## SERVICE BULLETIN REVISION TRANSMITTAL SHEET

MODEL BD-700-1A10 (BD-700)

Service Bulletin No. 700-35-6501  
Date of Basic Issue Sep 28/2020  
Revision No. 01 Dated Feb 12/2021

### MODIFICATION – OXYGEN SUPPLY SYSTEM – FLEXIBLE OXYGEN HOSE REPLACEMENT

**Figure 2 – Flexible Oxygen Hose Assy Modification**  
(Sheet 2 of 2, Rev. A)

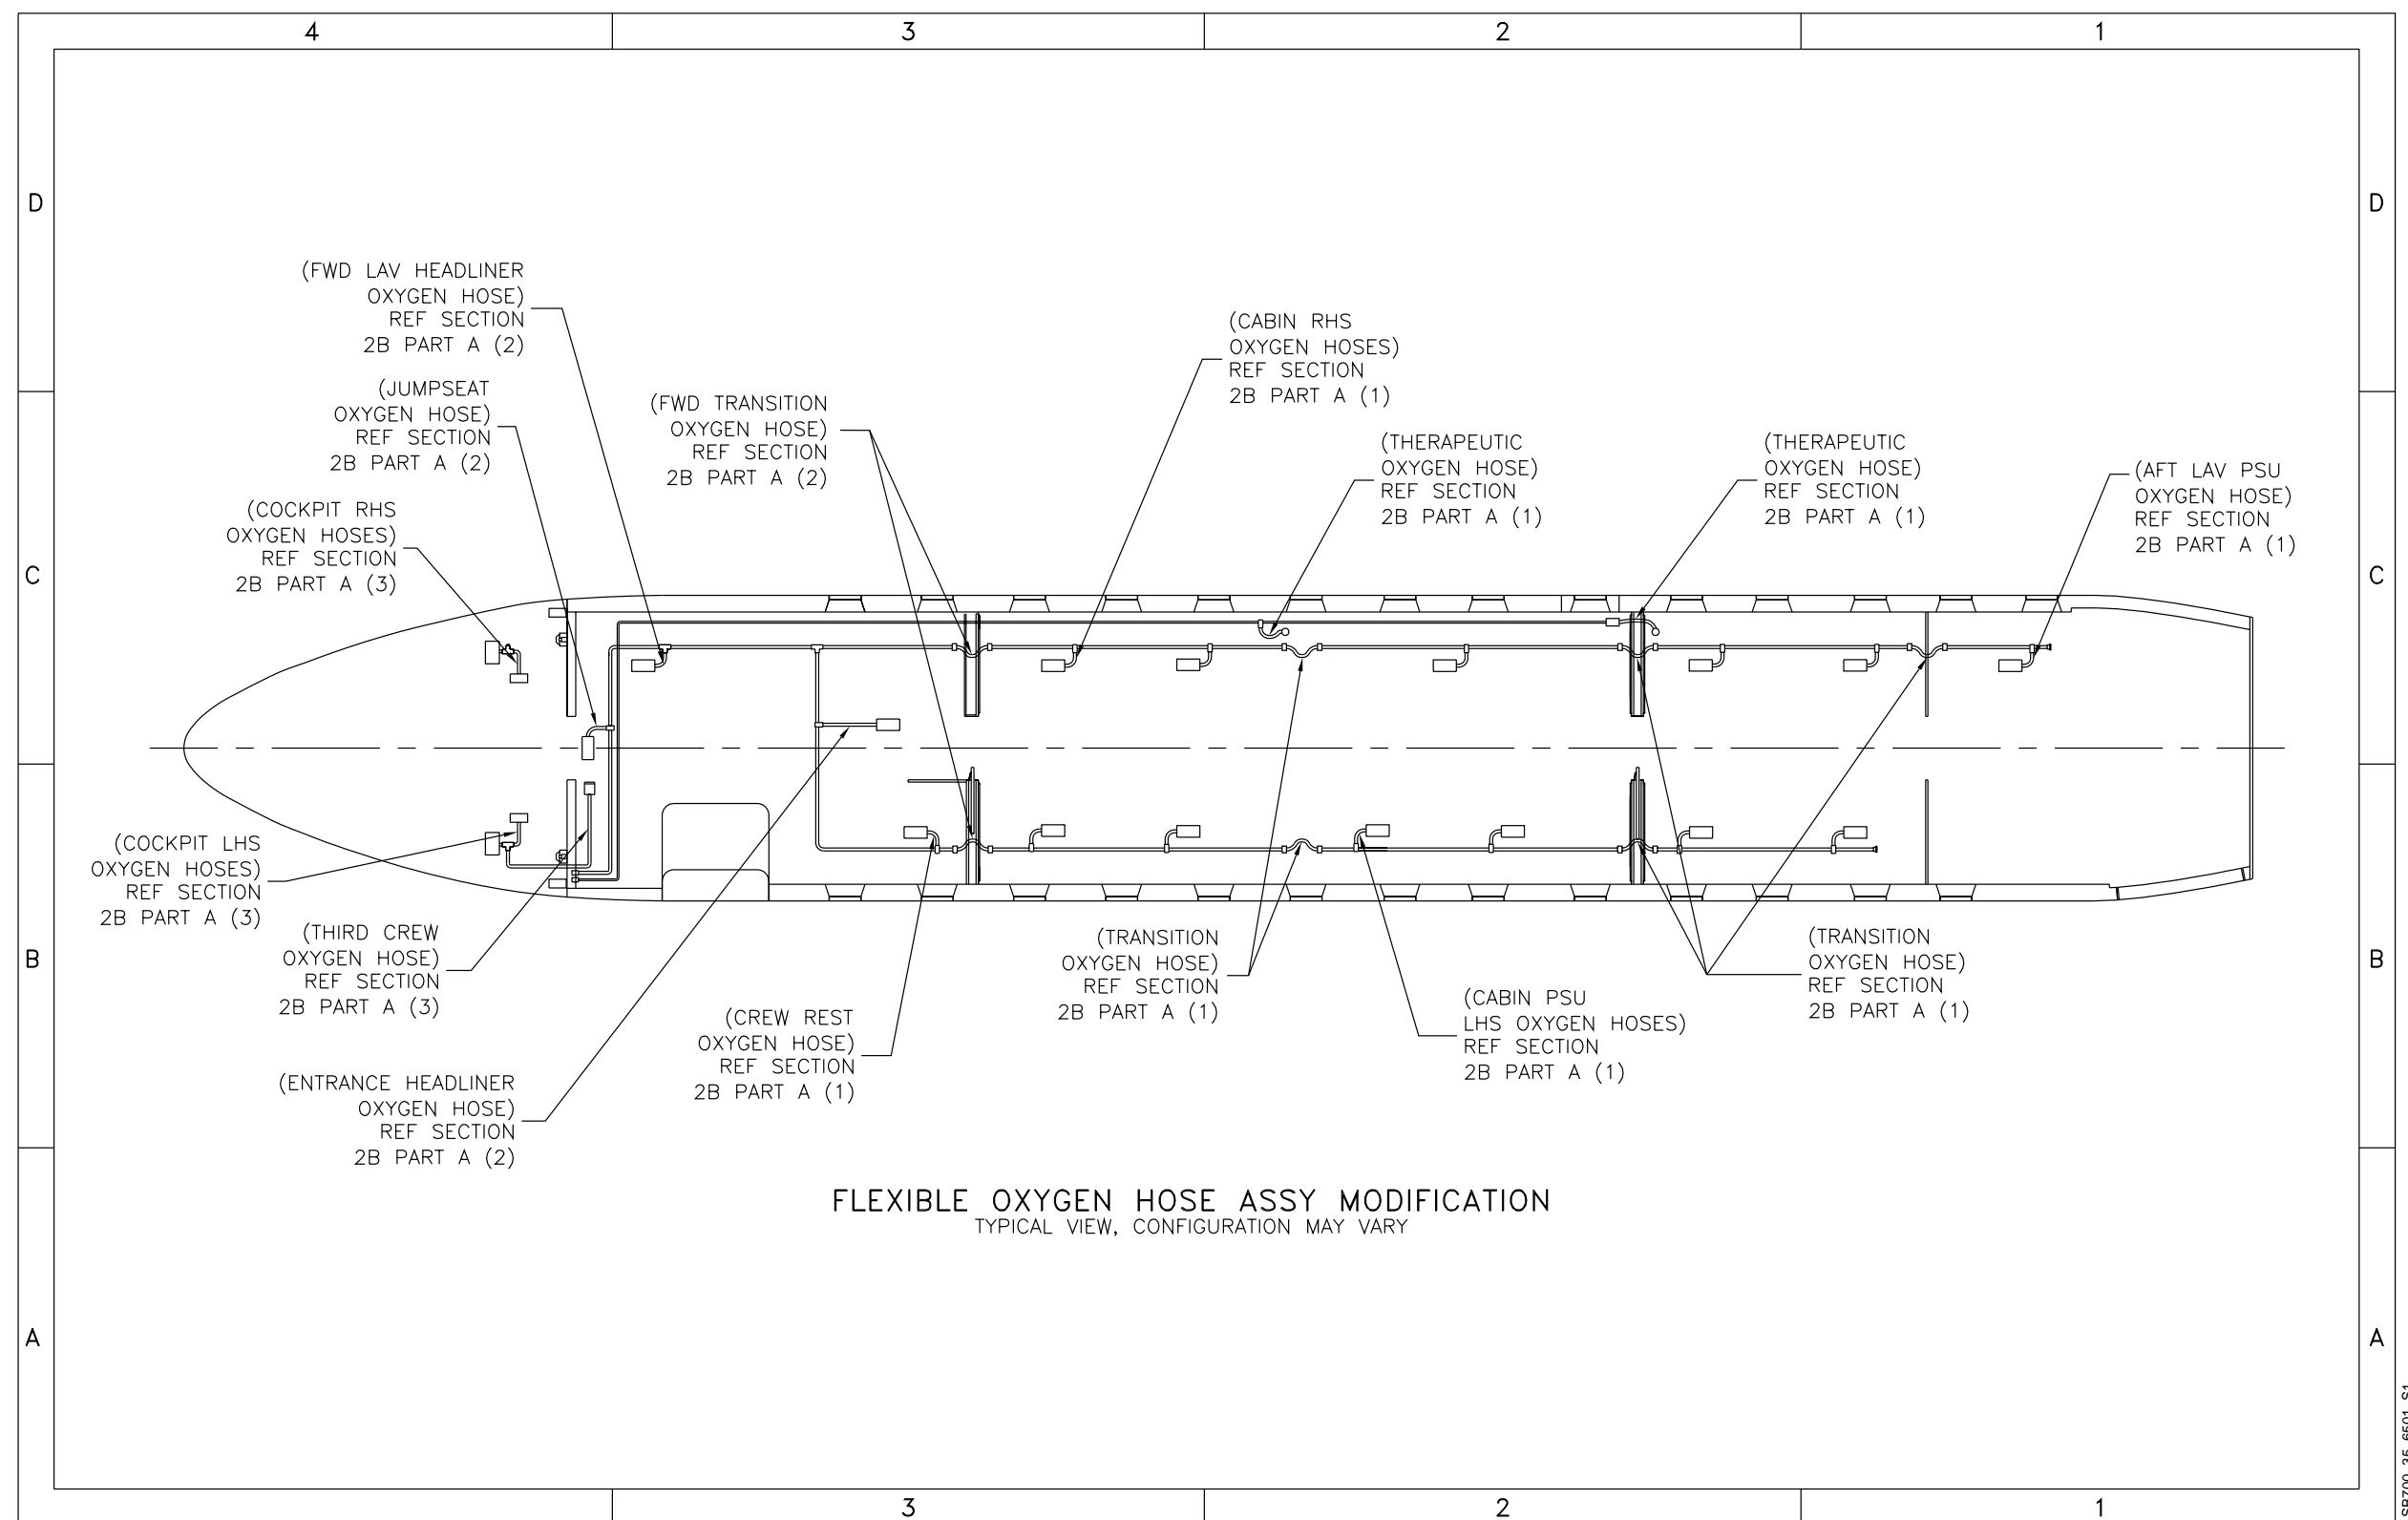
- (3) Remove and replace all O2C20T1 series hose installed at the locations shown in Figure 2 as follows. Refer to the applicable Notes on Figure 2:

- (a) Disconnect and discard the O2C20T1 series hoses.

- (b) Assemble the 3891X series hoses. Refer to SPM-MM 20-22-00-910-801.

- (c) Torque the fittings from 100 to 125 lbf in (11.30 to 14.12 Nm). Refer to SPM-MM 20-22-00-910-802.
